Seismic Evaluation Guidance

*Screening, Prioritization and
Implementation Details (SPID) for the
Resolution of Fukushima Near-Term Task
Force Recommendation 2.1: Seismic*

Draft Report, August 2012

Figure 1-1
Recommended Approach to Respond to Information Request 2.1

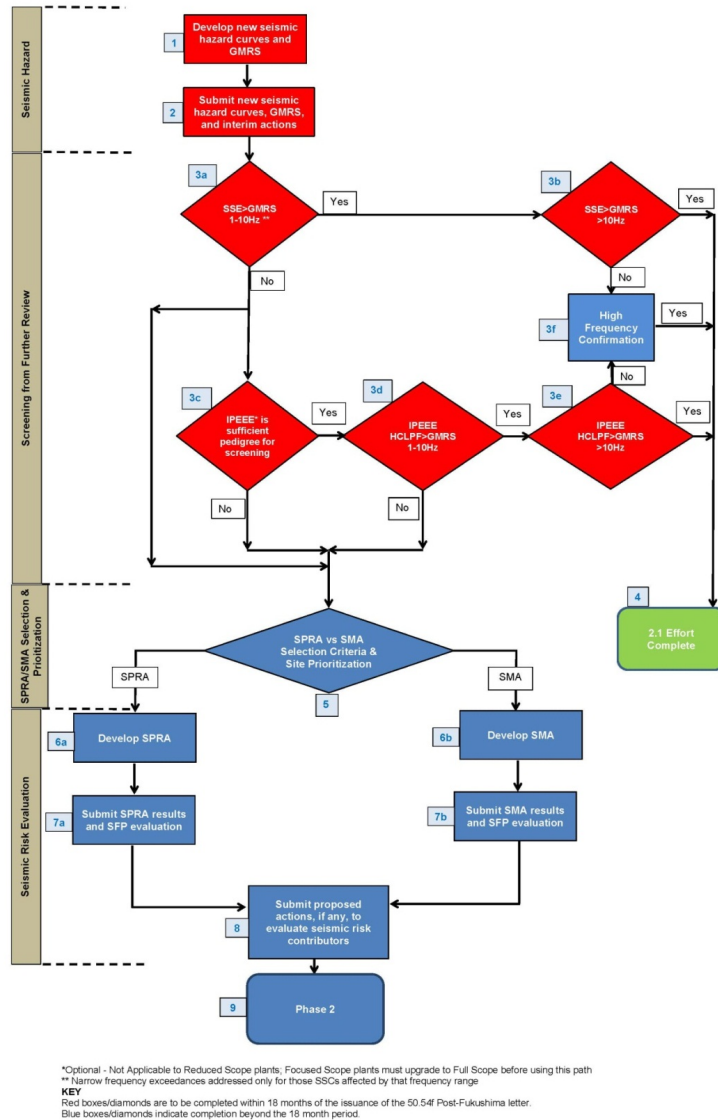
Comment [c1]: Need to be sure that all the screening approaches are incorporated so that everything is incorporated

Figure 3-2
Example Comparison of GMRS to SSE and LHT

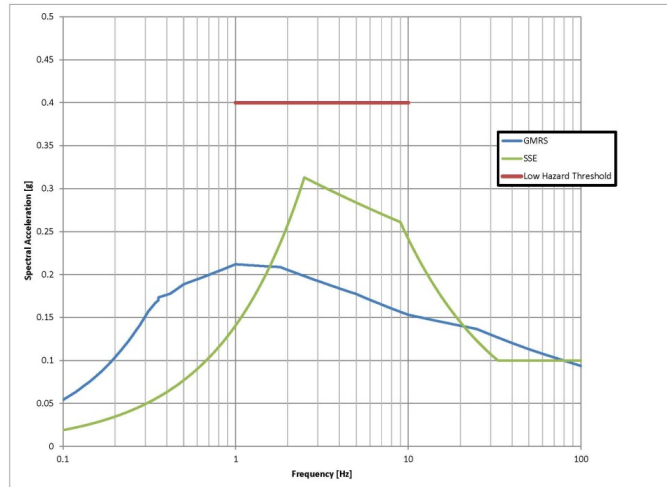
Comment [C3]: Should come after discussion of Figure 3-2 below.

Figure 3-3
Screening - Example Narrow Exceedances at 2 Hz and 6 Hz

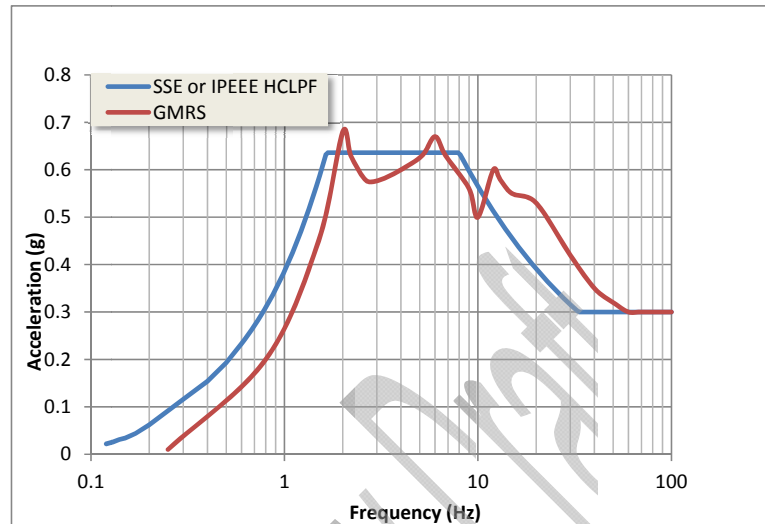
Comment [C14]: Has Figure 3-3 been updated to actually show this scenario? Last meeting it wasn't the case.

Figure 3-3
Example Comparison of GMRS to IHS

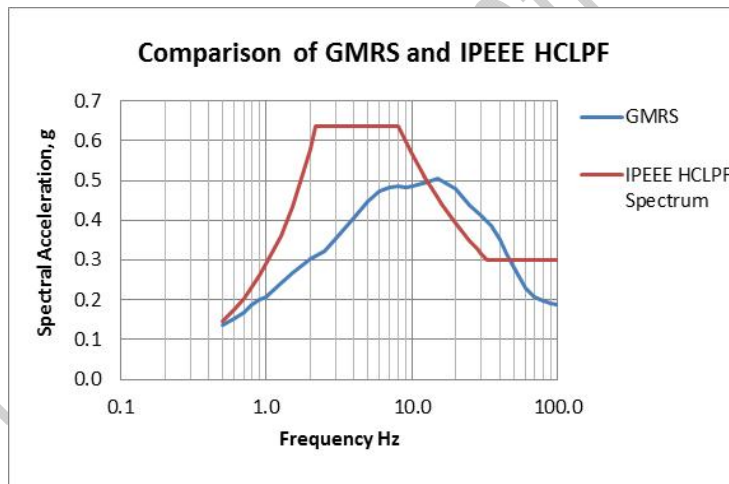
Comment [c18]: Problem with figure numbering from here forward in section 3

Figure 3-5
Sine Beat Test Input Motions

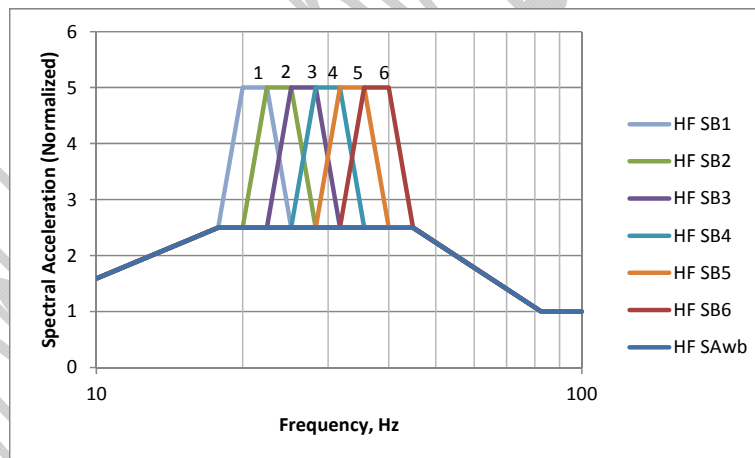
Comment [C23]: Is the sine beat also in the vertical direction?

Figure 6-5
Example of Ground Response Spectra that are Similar

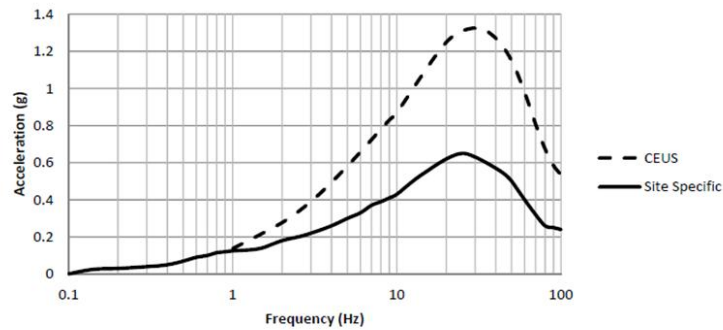
Comment [C25]: The ISG references the SPID in regard to the structural assessments (scaling, existing models, and using fixed base models for soft rock.). This section is focused on PRA, but we need it to also address SMA. Are the changes below all we need to extend it to SMA? Are they noted properly?

Figure 6-7
Reactor Containment Internal Structure, Operating Floor
East-West Direction, 5% damping

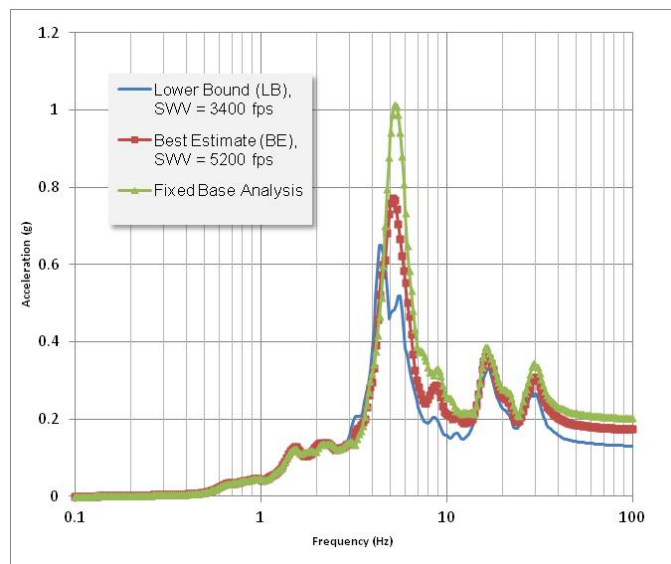
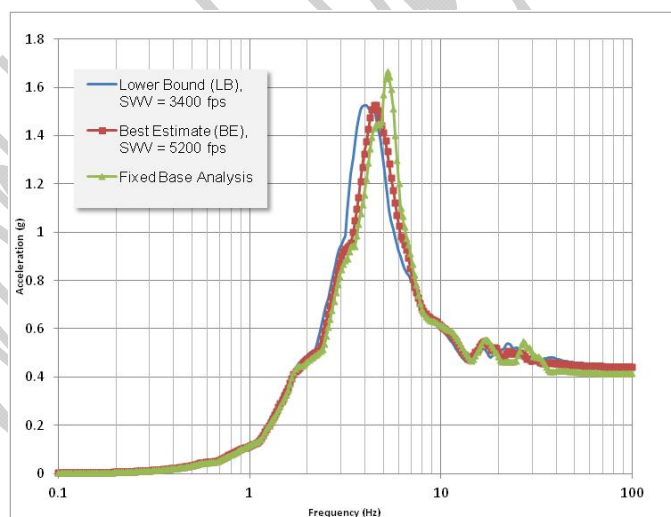
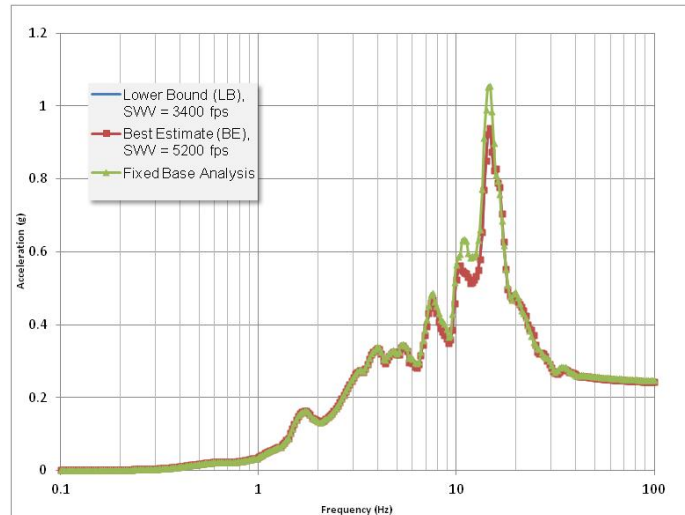
Comment [c29]: The conclusions/caveats from the two study cases need to be repeated in the main body.
